DOCKET 50-255 - LICENSE DPR-20 -PALISADES PLANT - RESPONSE TO IE BULLETIN 80-04 - ANALYSIS OF A PWR MAIN STEAM LINE BREAK WITH CONTINUED FEEDWATER ADDITION

Consumers Power Company's response to IE Bulletin 80-04 (Analysis of a PWR Main Steam Line Break With Continued Feedwater Addition) dated February 8, 1980 for the Palisades Plant is as follows:

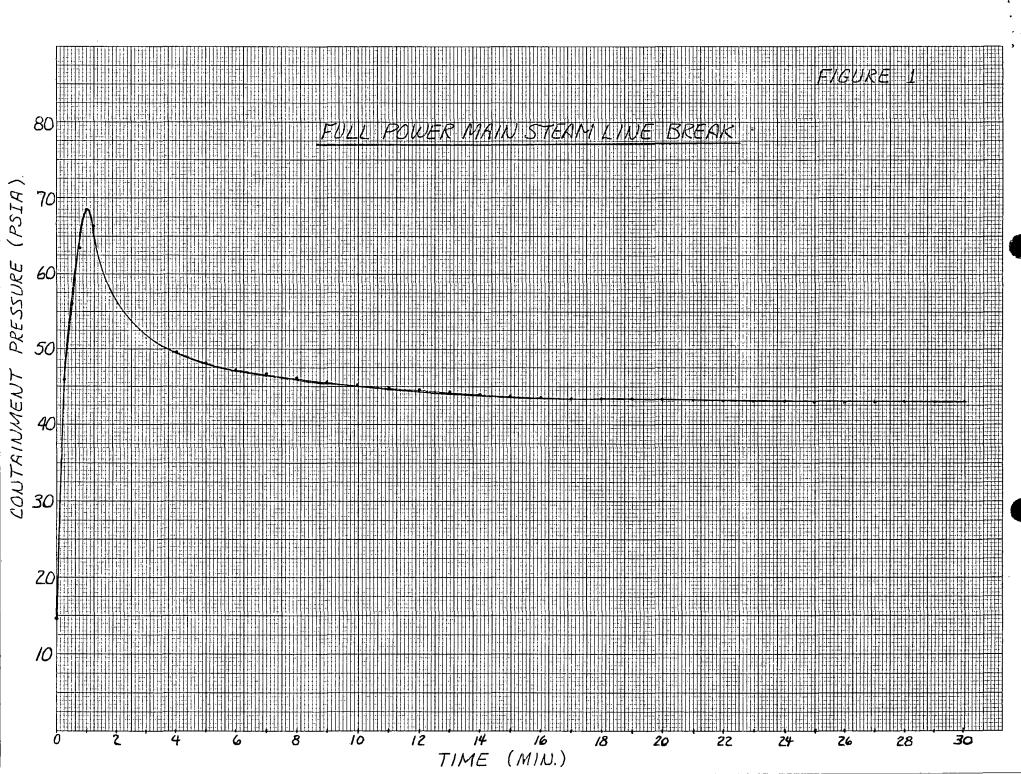
Review the containment pressure response analysis to determine if the potential for containment overpressure for a main steam line break inside containment included the impact of runout flow from the auxiliary feedwater system and the impact of other energy sources, such as continuation of feedwater or condensate flow. In your review, consider your ability to detect and isolate the damaged steam generator from these sources and the ability of the pumps to remain operable after extended operation at runout flow.

A plant modification is presently being performed to provide automatic starting of the Palisades AFWS. An analysis has been conducted to evaluate the effect of auxiliary feedwater flow on the containment pressure response in a Main Steam Line Break (MSLB). The assumptions made in this analysis are as follows:

- f. Runout flow from one auxiliary feedwater pump (assumed to be 750 gpm) is initiated at 120 seconds after the MSLB. The automatic AFWS actuation system incorporates a 2-minute timer delay and an automatic flow controller which will be administratively set to less than 250 gpm per steam generator. Failure of the automatic controller to provide maximum flow demand is assumed even though this represents a second single failure in addition to the diesel generator failure. The automatic AFWS logic blocks the start of the steam-driven auxiliary feedwater pump, unless the motordriven pump does not start and deliver flow. Therefore, only one pump is

For conservatism, the 750 gpm of cold feedwater was assumed to flash to steam with an enthalpy of 1183.1 Btu/lbm (saturated enthalpy at 80 psia). This assumption ignores any physical limitations on the amount of energy available within the primary coolant system to boil the cold feedwater.

The runout flow from one auxiliary feedwater pump will be less than 750 gpm (runout flow has been calculated conservatively to be less than 650 gpm). This calculation was based on a steam generator pressure of 0 psig and with known pump and injection valve characteristics. (Refer to FSAR Figure 9-11 for the auxiliary feedwater pump-head curve.) Acceptable pump performance at flow rates up to 690 gpm and with a net positive suction head (NPSH) of less than 10 feet (available NPSH exceeds 20 feet during actual operation) has been verified by vendor test.

The results of this analysis, in terms of containment pressure vs time, are shown in Figure 1. A single CTS pump (and three air coolers) are found to be more than adequate in removing the energy being deposited in containment as a result of auxiliary feedwater addition. At 30 minutes, the containment pressure is continuing to slowly decrease. It is assumed that by 30 minutes, the operator would recognize (by observing the steam generator pressure difference) that he was feeding the broken steam generator, and terminate feedwater to it.
